Service Bulletin

Applies To: 2009-11 TSX L4 with M/T - Check the iN VIN status for eligibility

Product Update: Software Update to Improve Fuel Injector and VTC Timing (Supersedes 11-021, dated October 22, 2011, to revise the information marked by the black bars)

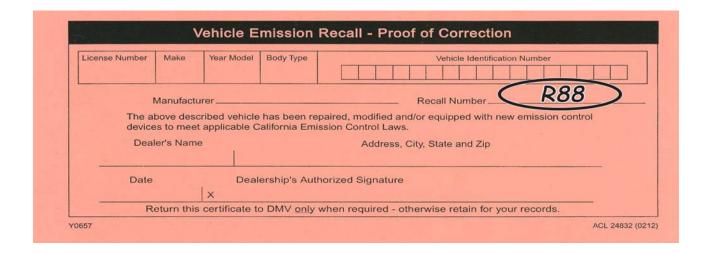
Under REPAIR PROCEDURE, the phone number was added for certificate ordering, and an example of the certificate was added.

3. For California Residents Only: Fill out a Vehicle Emissions Recall - Proof of Correction certificate, and use R88 as the campaign number. Give the certificate to your client, and advise him or her to keep it as proof that the product update was completed. Your client will need to submit the certificate to the DMV only if the DMV requests it.

If you need more certificates, contact Helm Inc. at **800-782-4356**, and use reorder number **Y0657**.
